**NOTICE OF A REGULAR MEETING
BONDURANT PLANNING AND ZONING COMMISSION
NOVEMBER 18, 2021**

TITLE: RESOLUTION NO. PZ-211118-26: Considering recommended approval of the Midstates Precast Products site plan at 2340 Hubbell Avenue SW

TITLE: RESOLUTION NO. PZ-211118-27: Considering recommended approval of the CDL training lot site plan at 2408 Robinson Avenue NE

LANDSCAPE PLAN

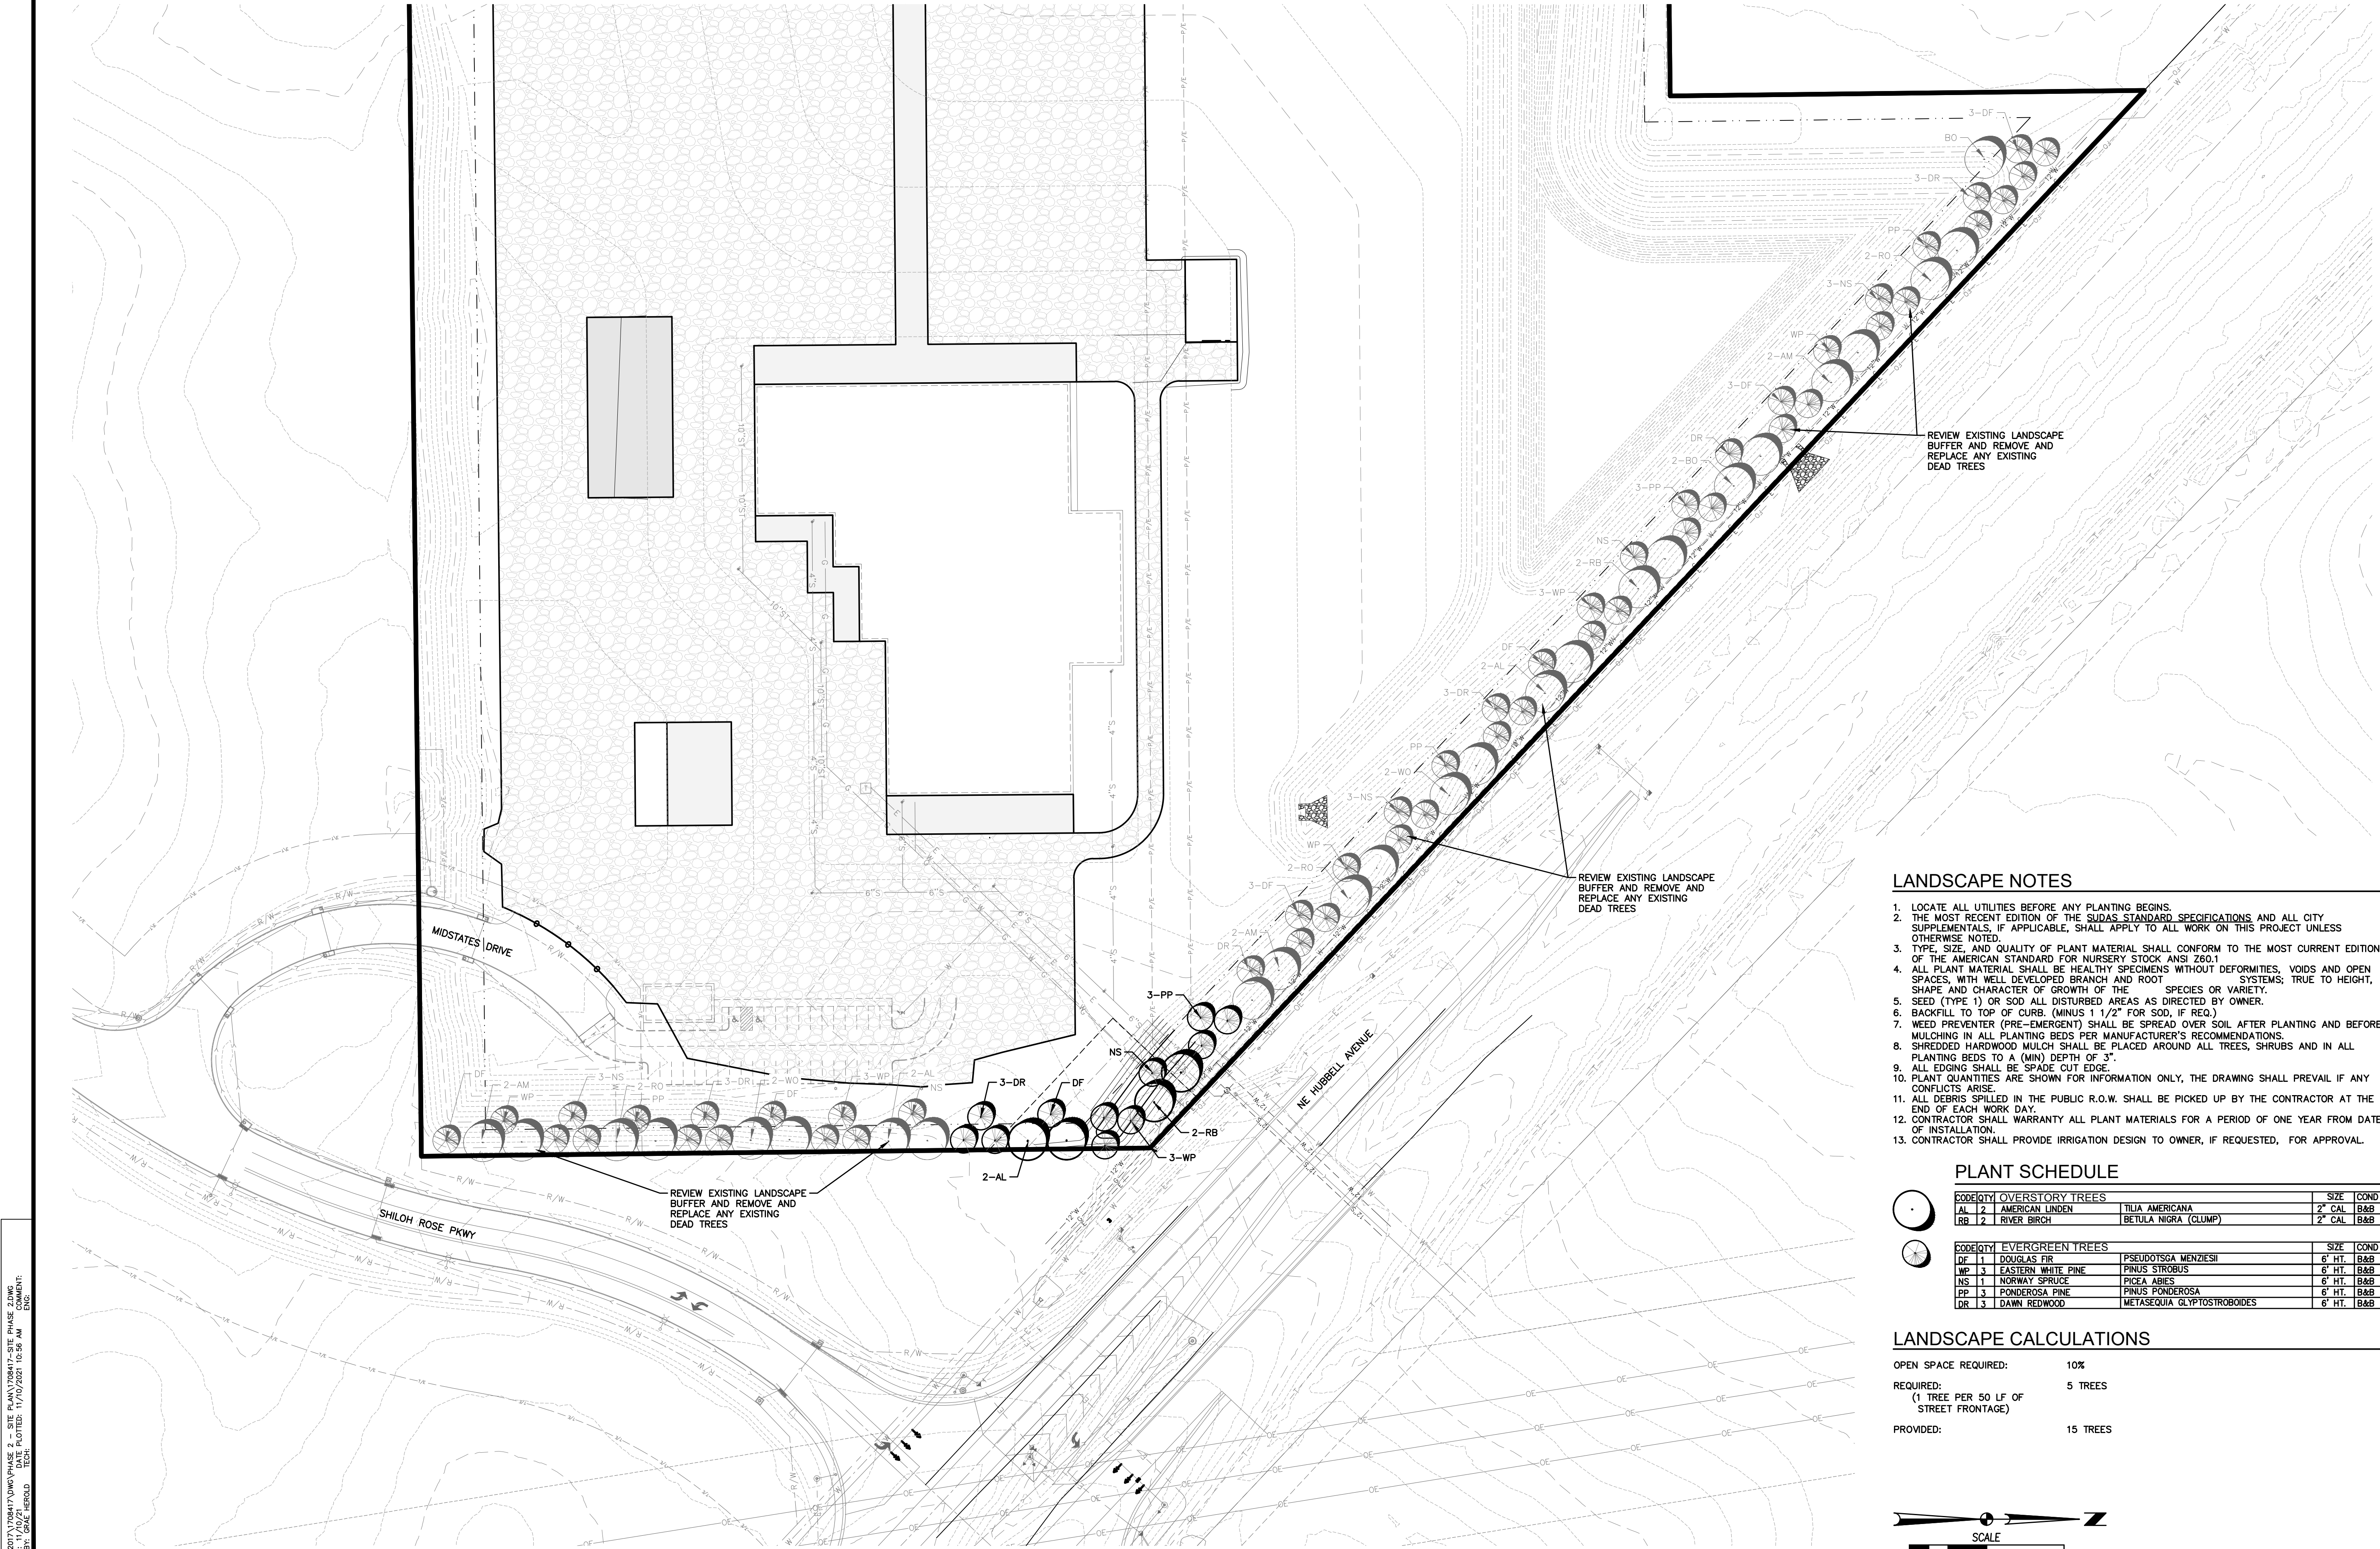
- Page 4 contains the required landscaping plan. It notes to review existing landscape buffer and remove and replace any existing dead trees. It also proposes a new portion of landscape buffer area in the area highlighted in yellow below - this site's access out to Highway 65 was formerly located in this area but has since been routed to the Shiloh Rose Parkway SW street connection out to Highway 65.

5. That the site plan must provide calculations on interior greenspace requirements.
6. That the site plan must provide calculations on minimum interior tree requirements.

C-100 - Site and Landscaping Sheet

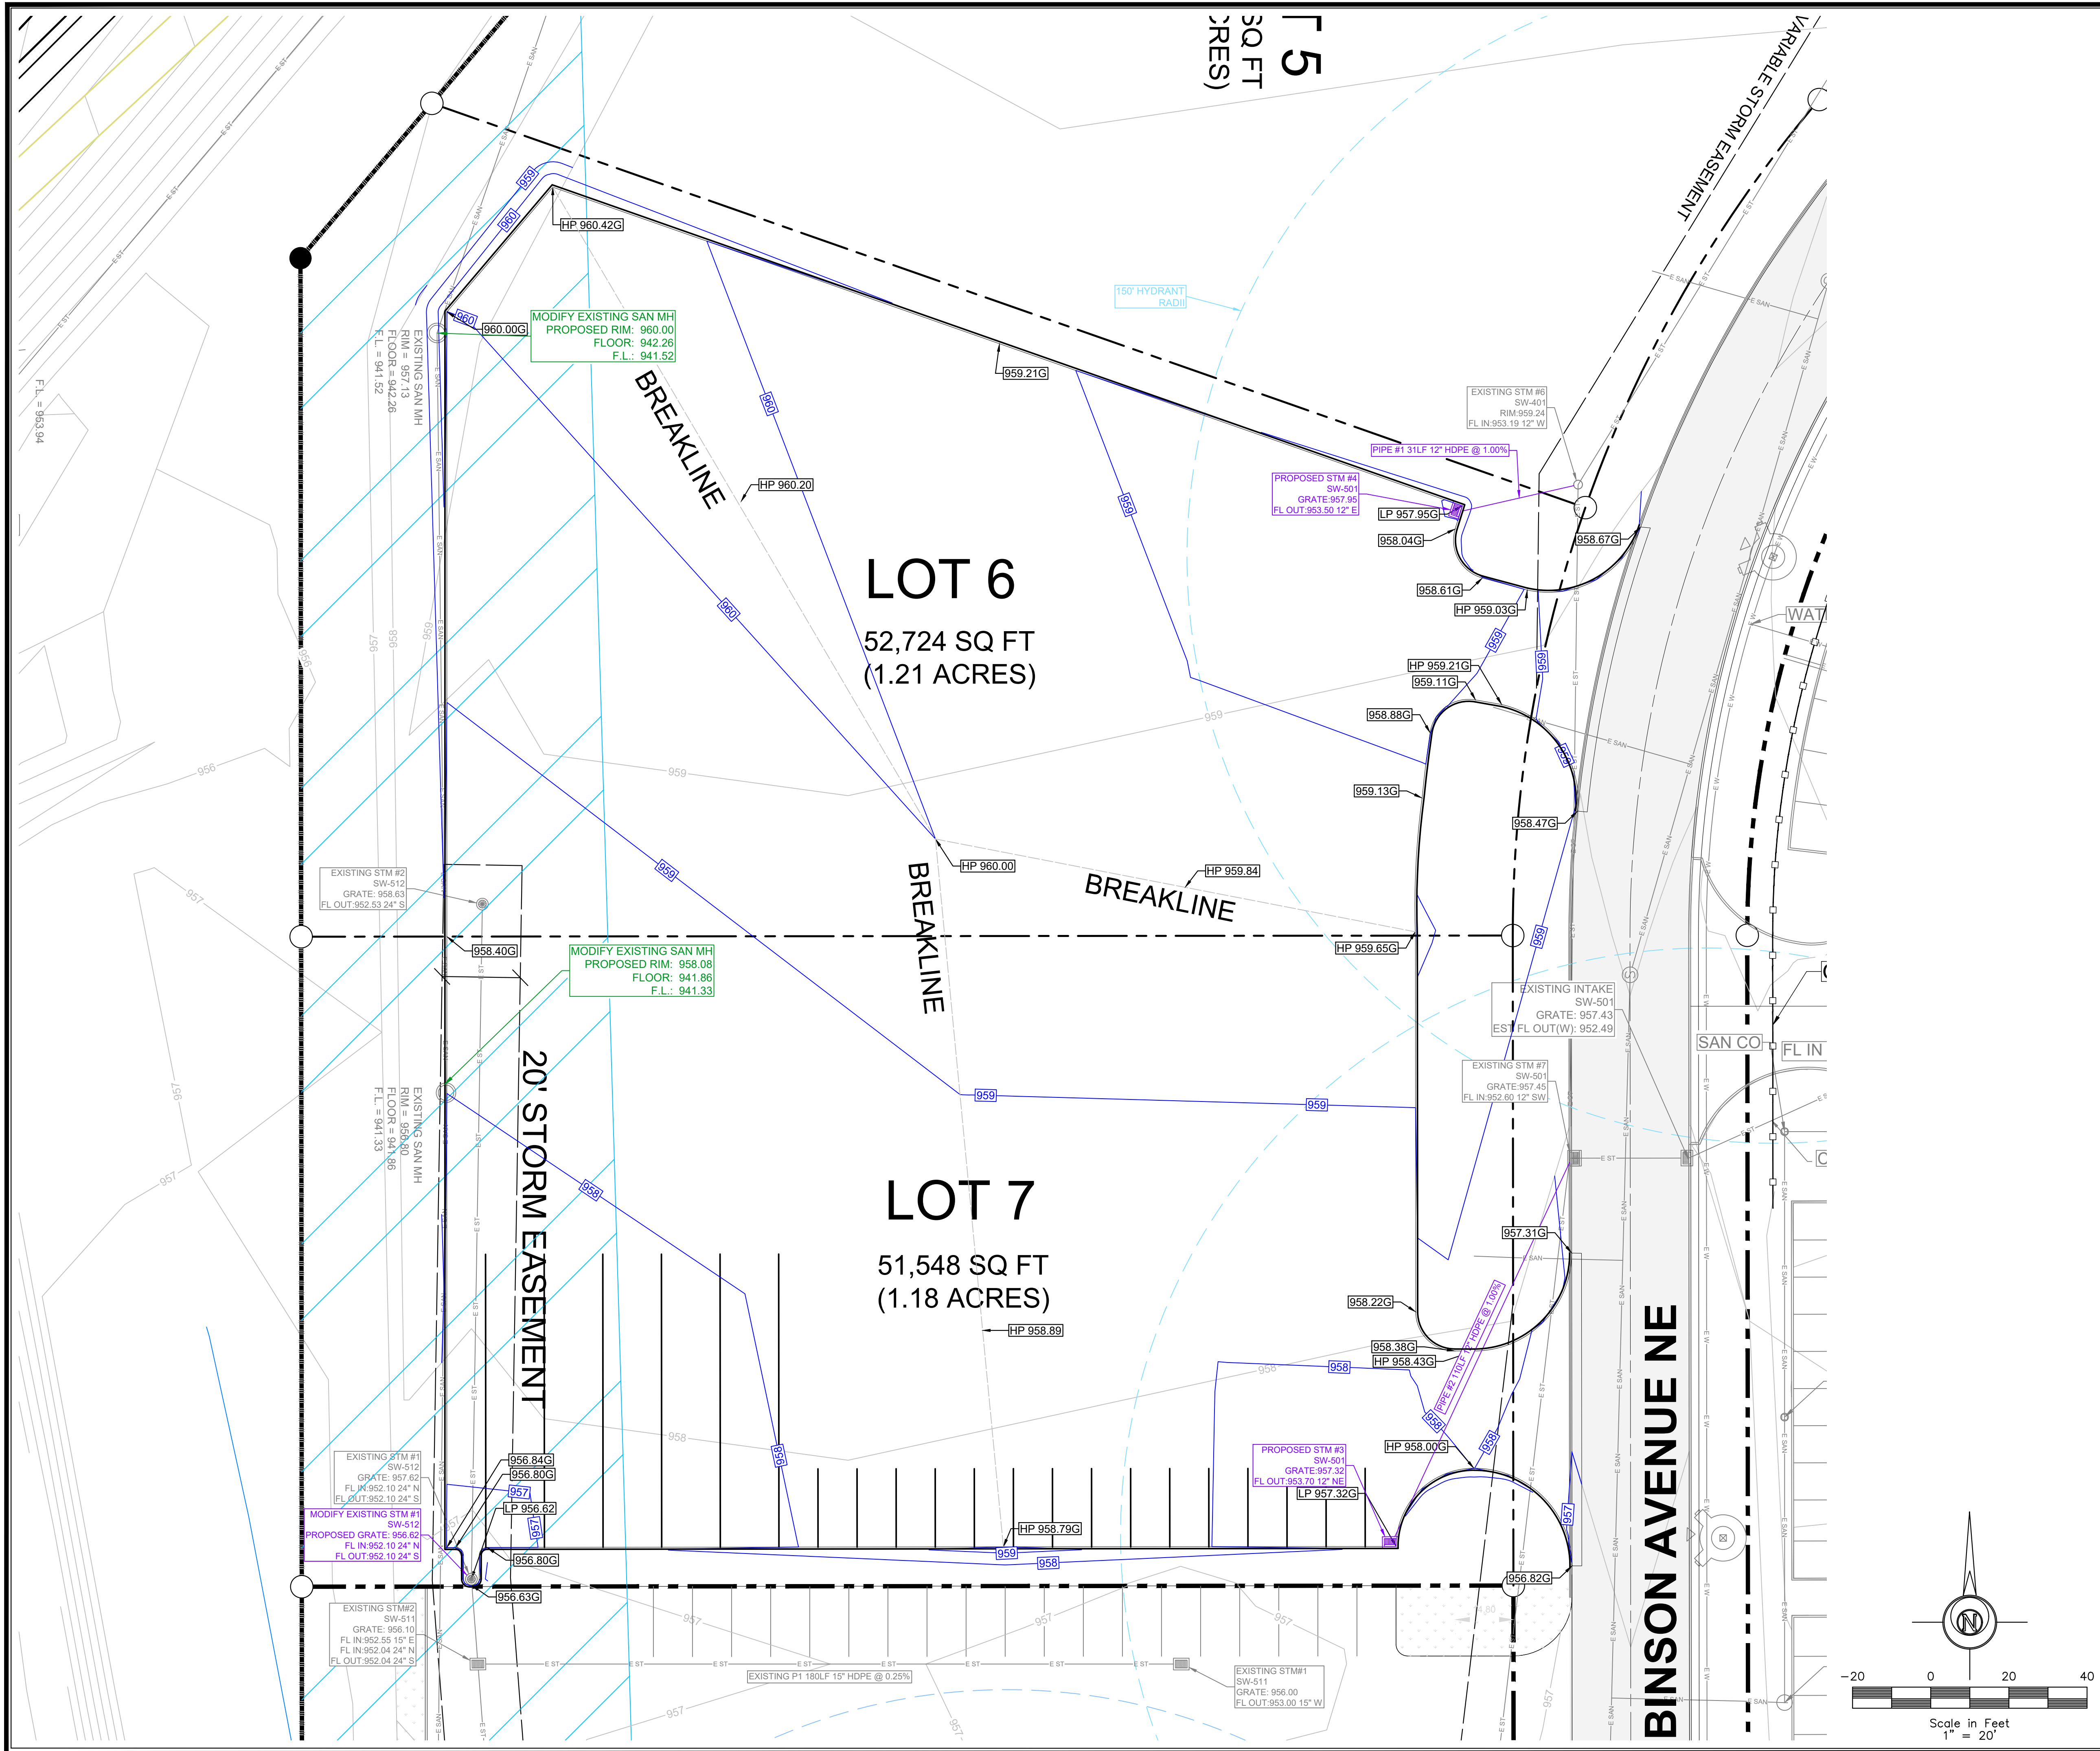
- Page C-100 contains the required landscaping plan. Notes on this:
 - This site has 277' of street frontage. The landscaping plan shows 6 general trees are proposed, however, it appears the site plan only shows 5 general trees on this site. Site plan to be updated to show 6 general trees on this site. The landscaping plan shows that these general trees will be planted within the M-2 District's 30' minimum front yard setback area. Site plan engineer to confirm the general trees will be planted at least 4' away from the front property line, as is required by Section 182.05.E.

- 15 parking spaces are proposed. 15/18 = at least 1 interior tree required. The landscaping plan does not currently show the interior tree in an interior parking lot island. Site plan to be updated accordingly.

- Site plan does not provide a calculation for the 5% minimum interior greenspace requirement, as is required by Section 177.10.7.a of the Zoning Code. Site plan to be updated accordingly.

6. The site plan must be updated so that it meets the landscaping requirements as noted in this agenda statement.
